**CEDAR CREEK STREAM AND WETLAND RESTORATION
PROJECT
MONITORING REPORT
MONITORING YEAR 4
FINAL**

SAMPSON COUNTY, NORTH CAROLINA
CONTRACT No. 005011 - PROJECT No. 95718
USACE ACTION ID No. 2012-00389 – NCDWR PROJECT No. 2013-0186

RE: Cedar Creek Stream and Wetland Restoration Site: MY4 Monitoring Report (NCDMS ID 95718)

Listed below are comments provided by DMS on December 14, 2018 regarding the Cedar Creek Stream and Wetland Restoration Site: Year 4 Monitoring Report and RES' responses.

Figure 8. 2018 Cedar Creek Groundwater Monitoring Gauge Hydrographs

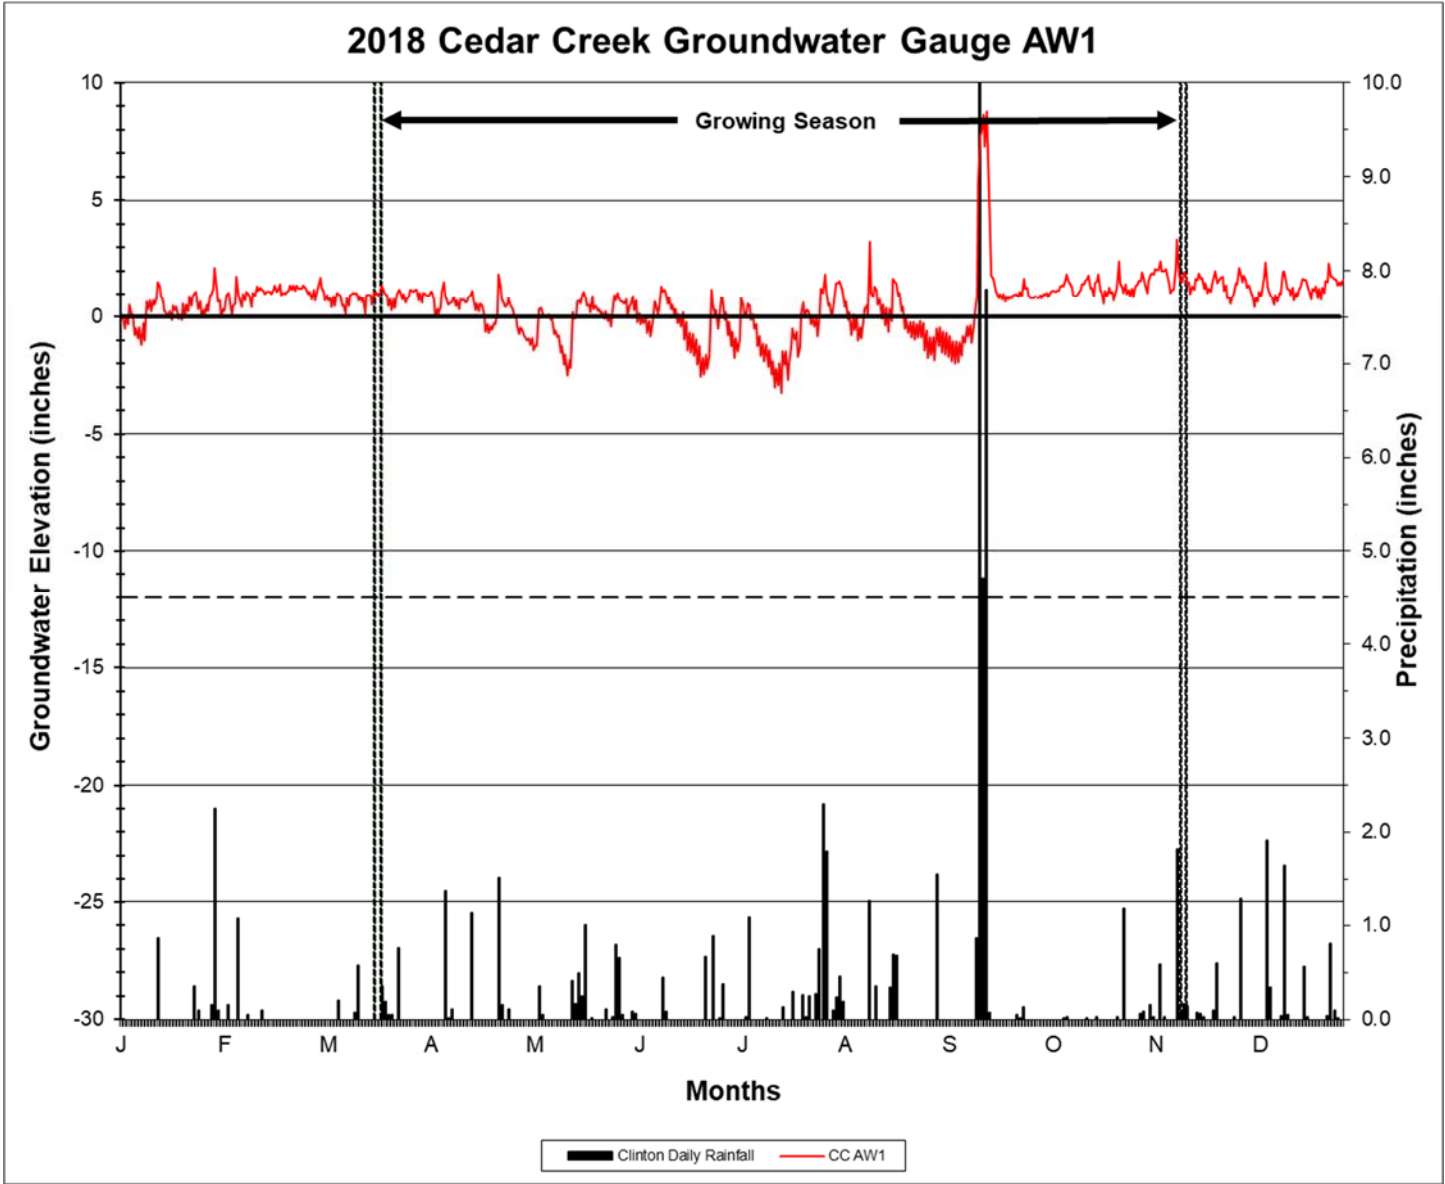
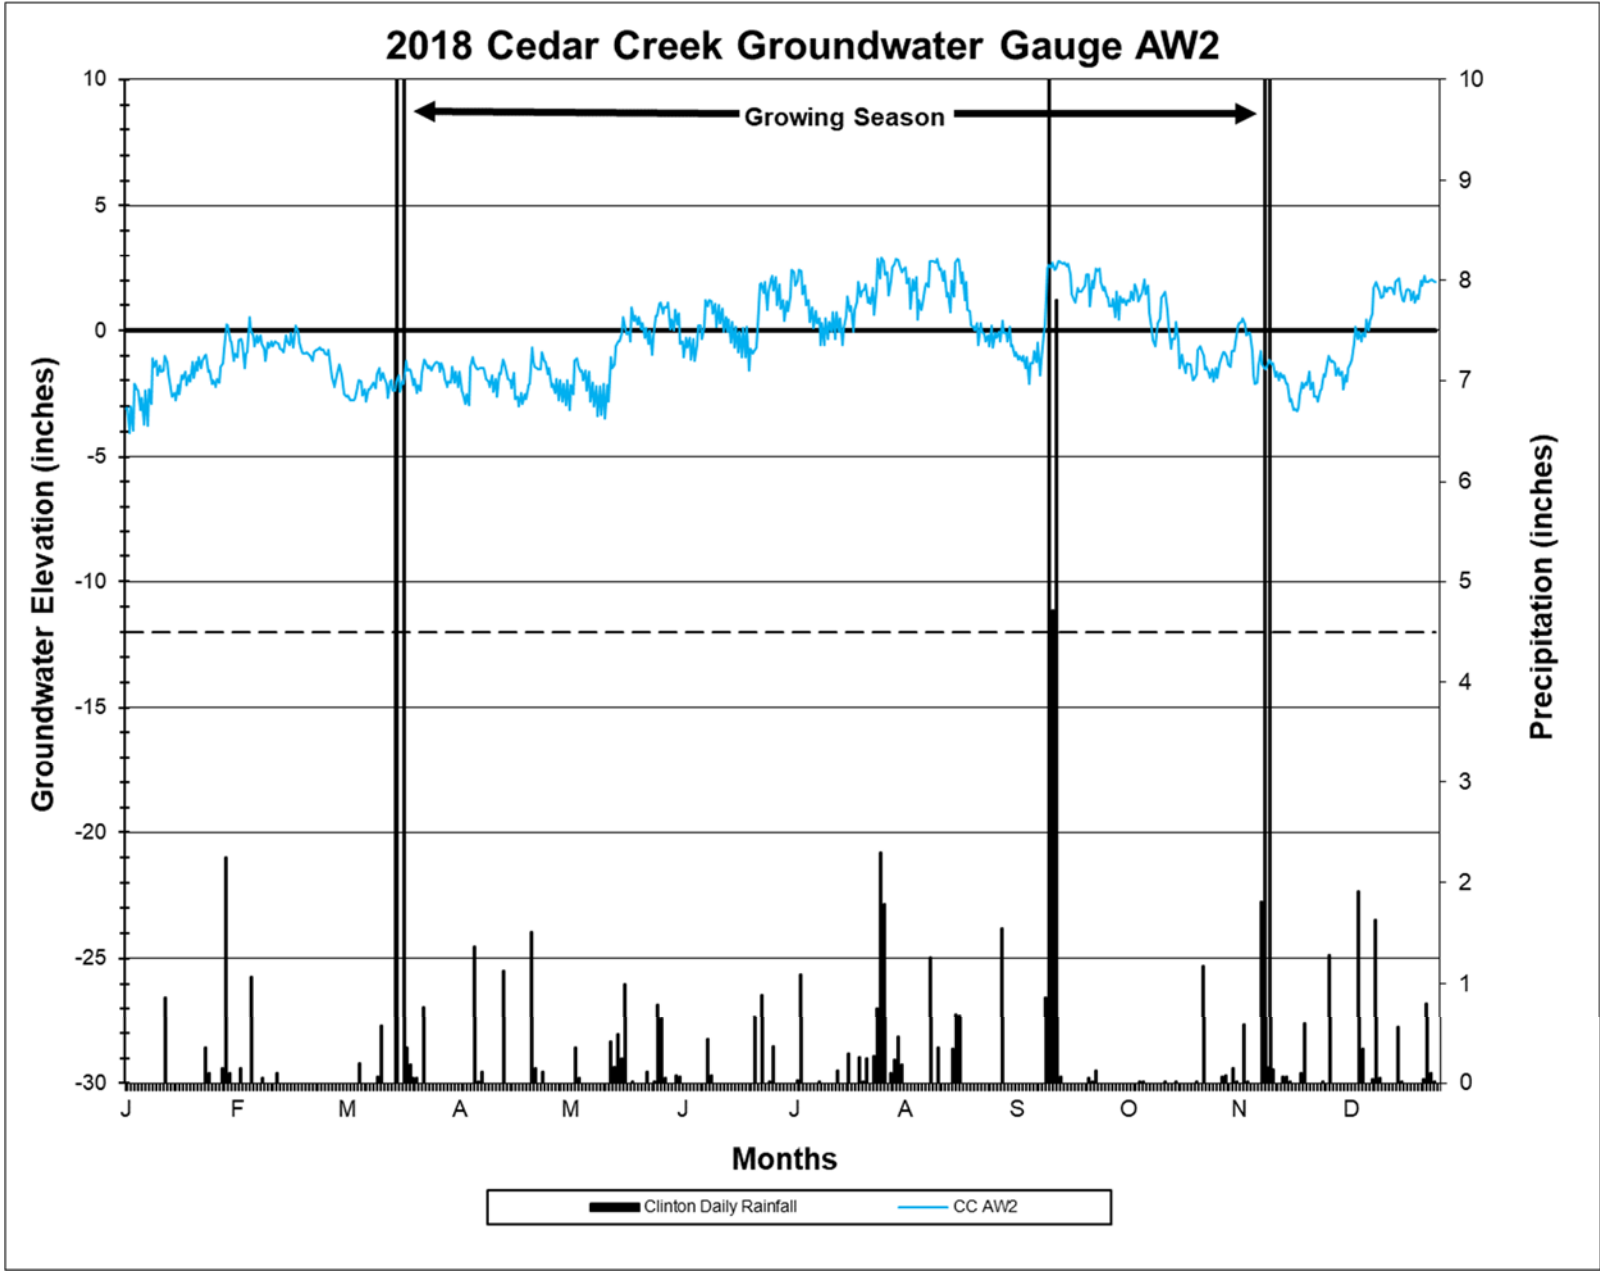
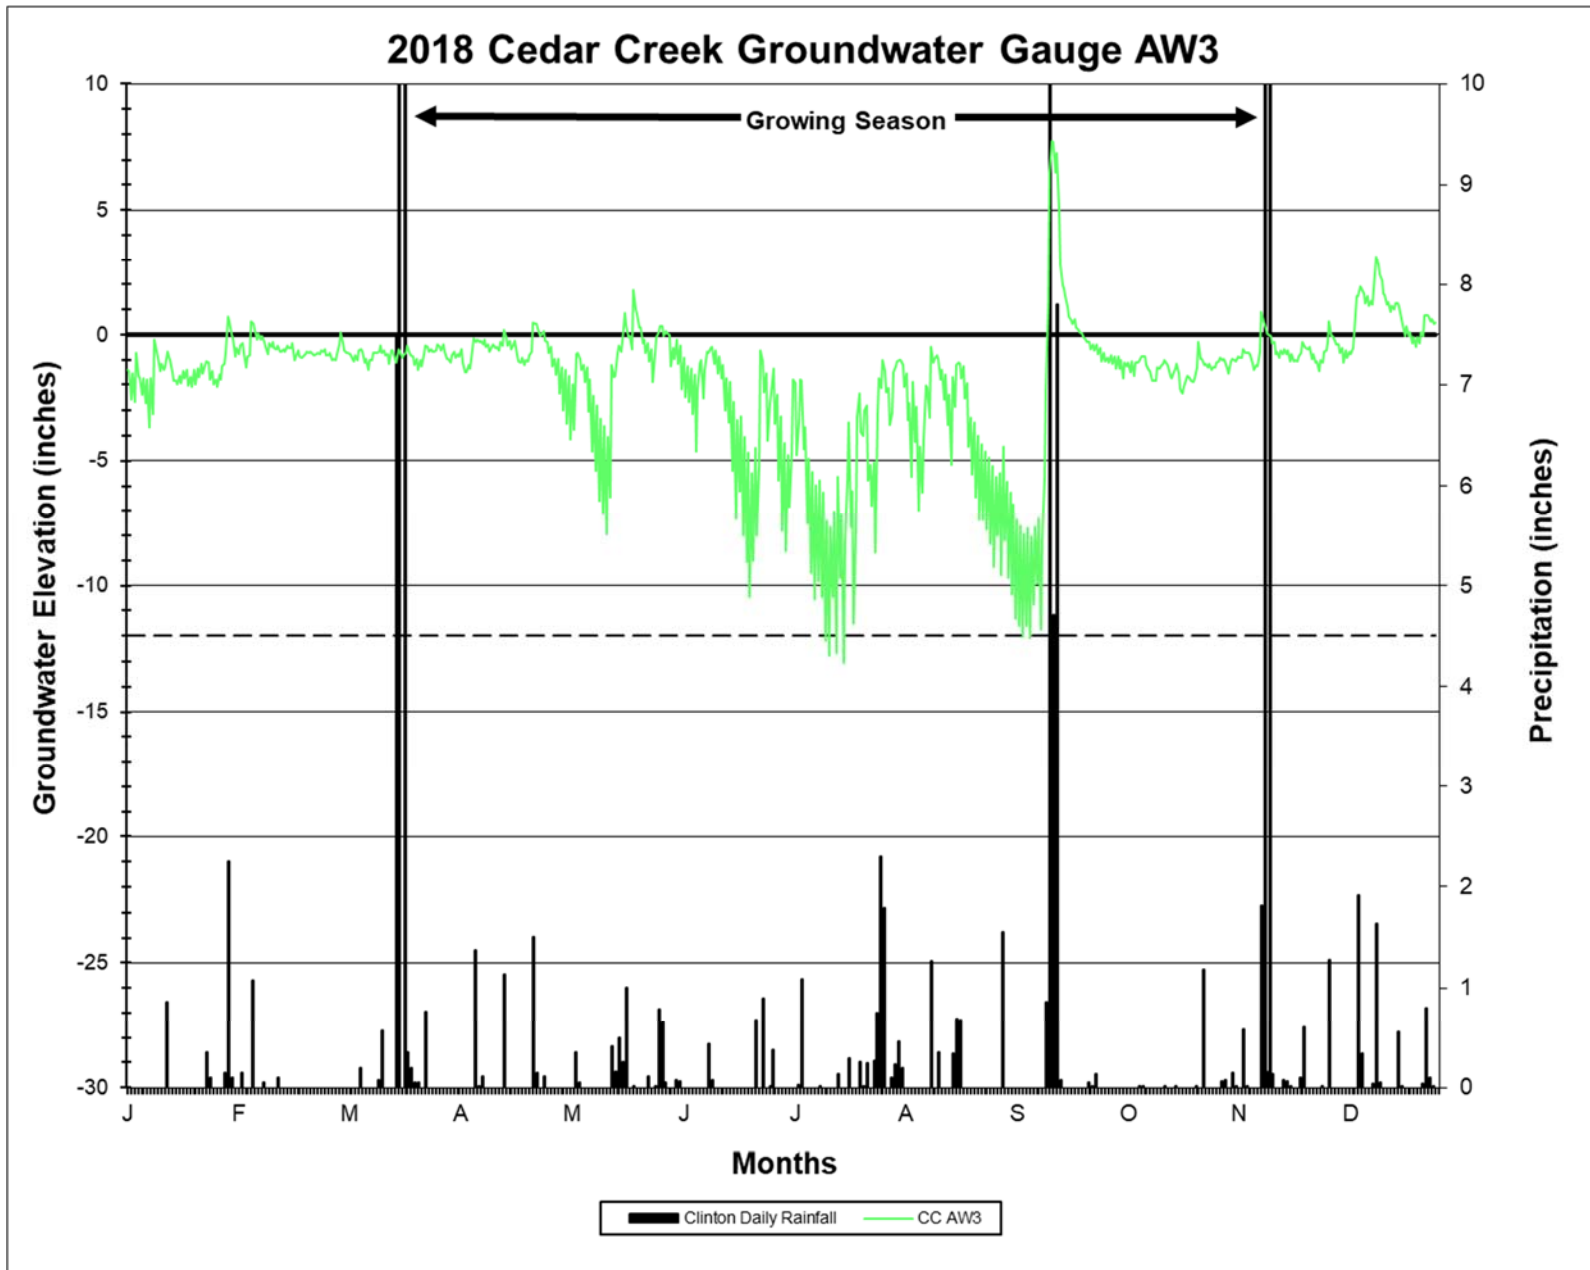
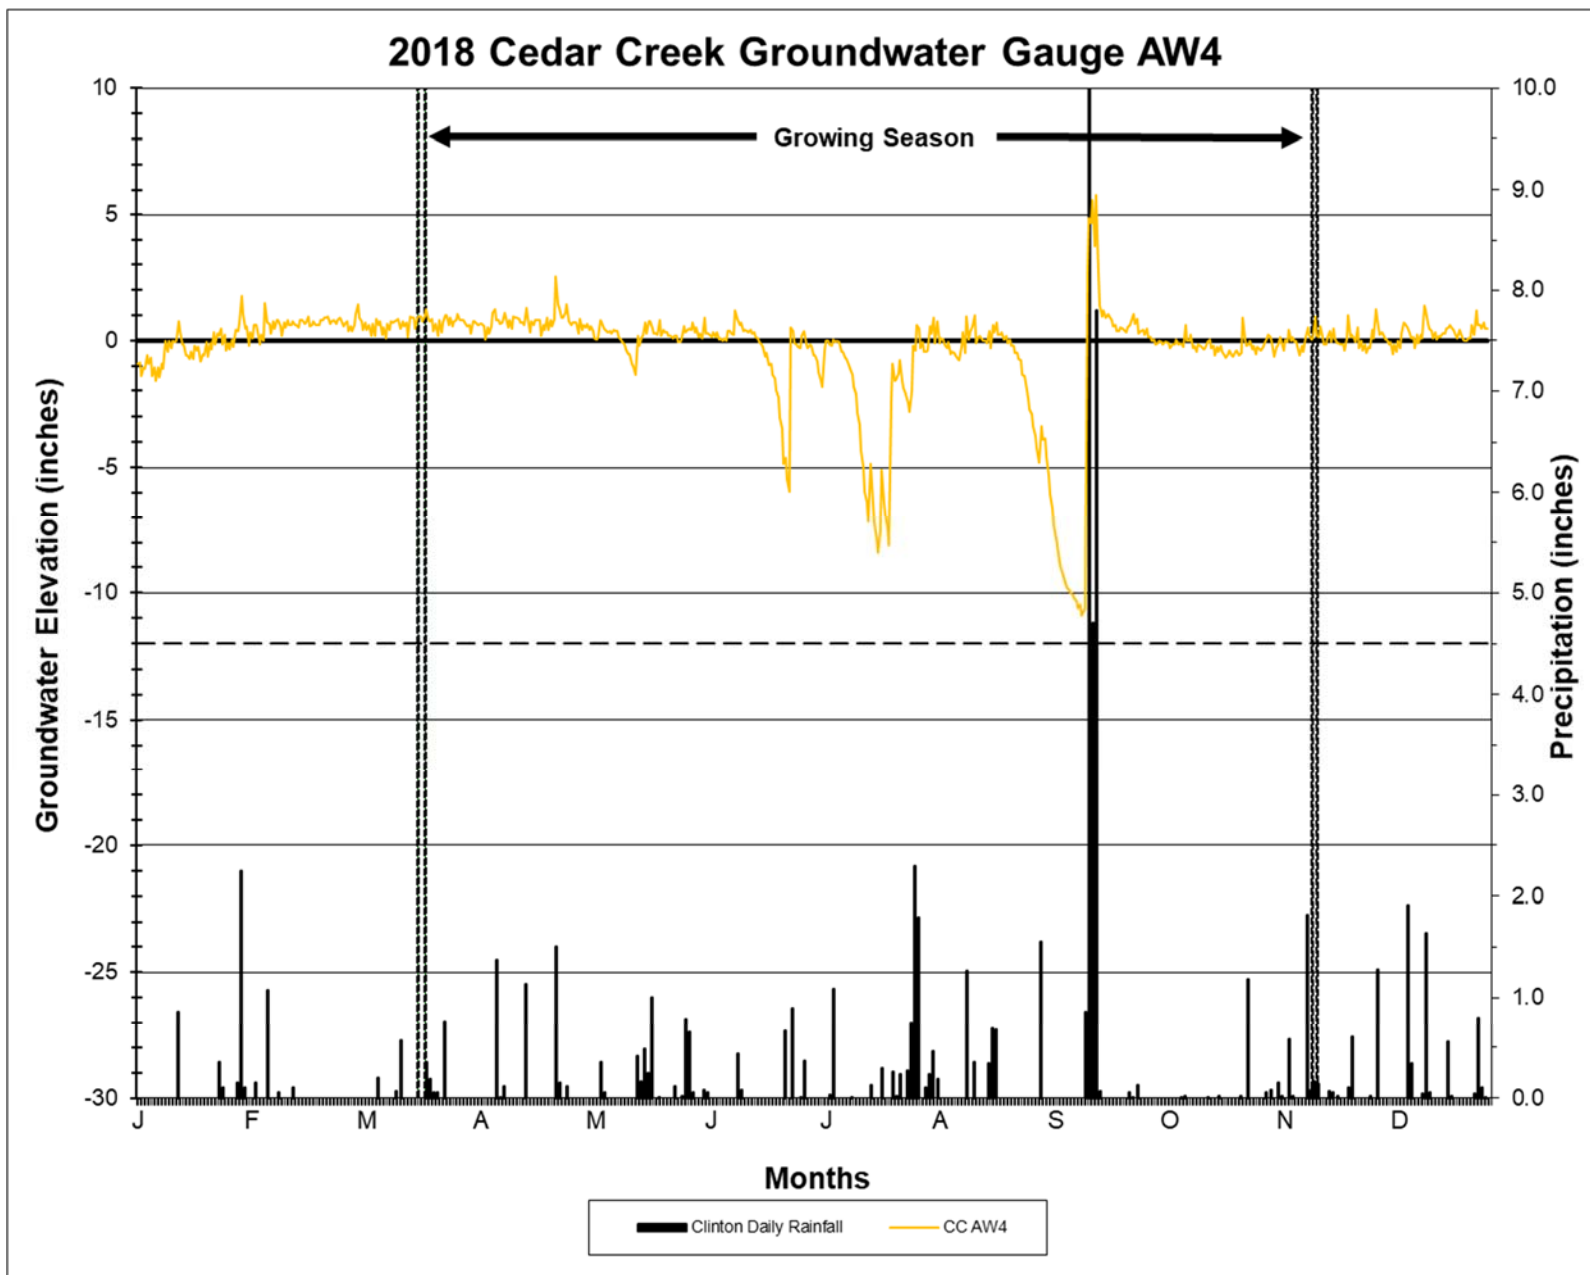
8. **Appendix E:**
 - a. 2018 Groundwater Monitoring Gauge Hydrographs: In reviewing these hydrographs, it appears that the entire growing season was not observed for the wetland assessment/gauge data collection. Please explain why not.
RES collected additional groundwater monitoring on January 10, 2019. The report now includes data from the entire growing season.
